The International Standard on Solid-State Relays (IEC 62314, Ed. 1)

Critical Review

Vladimir Gurevich, Ph. D.,

Israel Electric Corporation

Fig. 1. Solid-state relay rated for both AC and DC loads

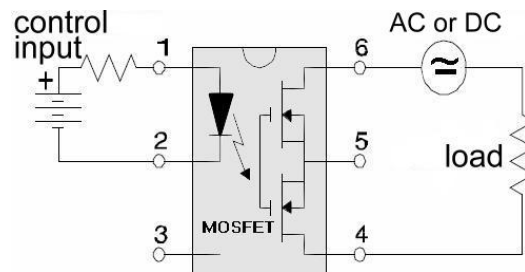
1.1. In this section I focus on the scope of the standard. According to the standard the scope is limited to solid-state relays with rated voltages of up to 750V and AC currents up to 160A. In the remarks it is noted that requirements for solid-state relays with DC output circuits are under consideration. These remarks are a little bewildering: what is the necessity to release a standard on the solid-state relays that covers only a small fraction of the solid-state relays that are available in the market today? In fact, many types of solid-state relays with the output element in the form of two powerful MOSFET transistors can switch both AC and a DC current, Fig. 1. The absurdity of the situation becomes apparent when one considers that only half of such relay (AC) is covered by standard IEC 62314, while the other half of the same relay (DC) is not covered.

Even the standard itself (in note to Section 3.1.8) recognizes that “the same solid-state relay may be ... rated for both a.c. and d.c.”

Fig. 2. Solid-state relays from Crydom with monolithic structures embedded in epoxy resin and integrated with a heat sink

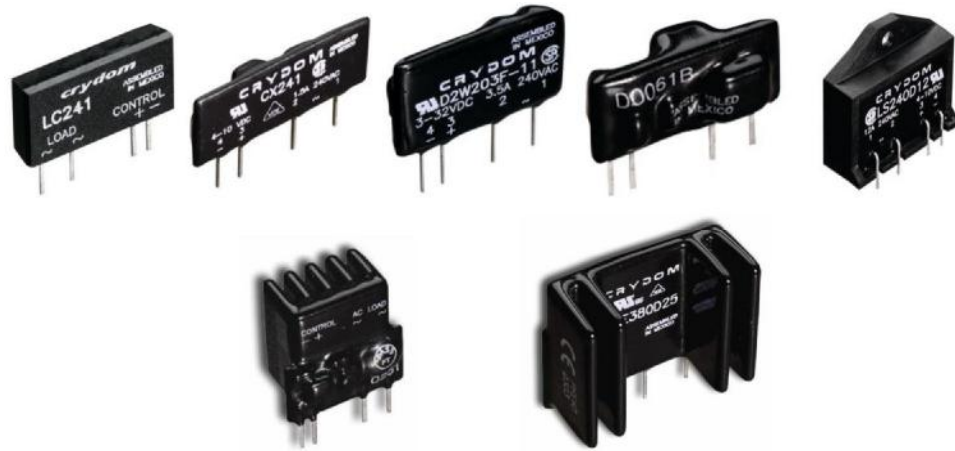
1.3. According to standard “solid-state switching device with monolithic structures fall within the scope ... and are not covered in this standard”, however it does not explain what is exactly “the monolithic structure”.

Besides the definition for “the solid-state relay” given in Section 3.1.1 (the analysis of this definition is given later in this article) does not expel presence of the monolithic structure in the solid-state relay. In fact, the terms “solid-state” and “monolithic” are almost synonymous! Such absolutely non-valid restriction of a scope is, in our opinion, inadmissible. For example, it is possible to buy solid-state relays from a widely known company, Crydom, with many years of specializing in the production of such relays, Fig. 2, which represent monolithic structures, embedded in plastic or filled with epoxy resin. In some cases, as a uniform monolith it is integrated as well with a heat sink. According to standard IEC 62314 it is claimed that these relays fall within the scope only because they filled by epoxy resin? What logic is in this is not clear!

Fig. 5. Solid-state relay controlled by mechanical switch (push button, for example)

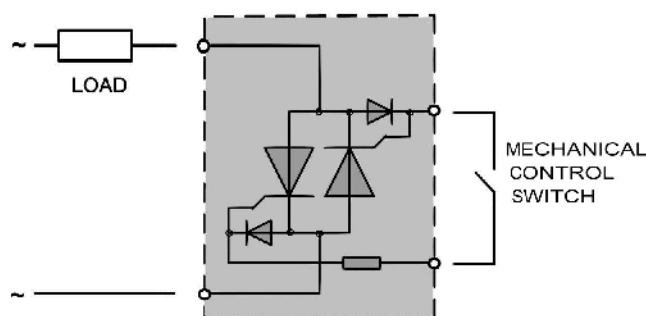
Apparently, from the definition given in the standard, the principle of construction of an input control circuit stipulates only that it should not contain any moving components, while the output power switching circuit is not characterized in any way. Therefore, under the definition given in the standard, any solid-state relay may be a suitable device that consist semi-conductor input sensing transducer (optocoupler, for example), the semi-conductor amplifier and the output electromagnetic relay. On the other hand, well-known relay design in which it is embedded epoxy resin, includes a semi-conductor output switching element (the thyristor, the transistor) controlled by a reed switch. The control coil of the reed switch forms a magnetic control circuit of the relay. The relays based on this well-known principle are widely used [2, 3]. But the reed switch contains internal moving components, so, such a device cannot be referred to as a “the solid-state relay” in spite of the fact that it meets to all requirements of standard IEC 62314 except the definition of the term: “the solid-state relay”. Another example is a unit containing two back-to-back connected power thyristors (the natural solid-state switch) controlled by external push button, Fig. 5, is this a “solid-state relay” or not?

In our opinion definition of the term “solid-state relay” presented in IEC 62314 is not correct and requires revision with an orientation to the "solid-state" character of the output element that is carrying out switching of an external circuit (load) instead of to the design of a control circuit.

Fig. 6. Examples with different properties for same insulation material which both suitable for the “solid insulation” definition

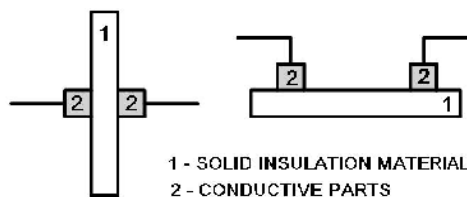
First, the LED on an input of solid-state relay and photodetective diode, connected in control circuit of the output switching element are each encased in plastic, i.e., not conductive. Despite this, sometimes optical clear insulation material is interposed between these two elements enclosed in dielectric cases to increase the dielectric strength. So, the definition is not suitable for this situation.

Secondly, both examples shown in Fig. 6 are suitable for the “solid insulation” definition but the properties of this insulation for the same insulating materials and same conditions are absolutely different. It is not clear what the necessity was to introduce this term into the standard and to give it a special interpretation. In our opinion, the term and the definition are absolutely unnecessary in a standard on solid-state relays.

Fig. 7. Solid-state relay with incorporated protective element which can be disconnected from the main terminals for the period of tests due to removal of external links (bridge).

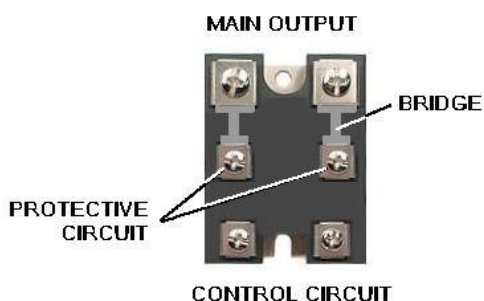
In Section 8.2.1 a), 2) it is emphasized (by underlining) that the overload capacity the solid-state relay “utilizing a current-controlled cut-out device in addition to an overcurrent protection ... shall be tested with the cut-out device in place”. In other words, if the solid-state relay is used in a concrete electrical installation together with the protective automatic circuit breaker, it should be tested for overload capacity together with this circuit breaker. So, what are we testing in this case: the solid-state relay or circuit breaker? According to standard requirement it is the circuit breaker. We already noted above that standard requirements connected to testing solid-state relays by voltage higher than the rated level do not specify concrete points (circuits) between which the test voltages should to be applied. It is incorrect and should be corrected, also for Section 8.4 Insulation tests. However, this will be only a partial solution of the problem. More complex is the problem of test withstanding the voltage of the output switching element of the solid-state relay.

The problem arises because many constructions of solid-state relays contain built-in internal structures for overvoltage protection (more often, varistors) which, naturally, have lower pickup thresholds than the installation protected by them (that is, the solid-state switching element of the solid-state relay). Thus, short-term, step-up pulses of a voltage on the relay terminals at tests will lead to pickups of this protective element. The long duration, for example, approximately one minute, of the step-up voltage during the tests will lead to the destruction of a protective element. Thus, it is impossible to perform normal withstanding voltage tests for many solid-state relays constructions.

The problem may be solved by changing a principle of connection of a protective element to output relay terminals at which this protective element could be disconnected from the terminals for the period of tests due to removal of external links, Fig. 7. Such a change in the design of the solid-state relay would allow solving a problem of tests and should, in our opinion, be introduced into the standard as the obligatory requirement to construction of the solid-state relays.
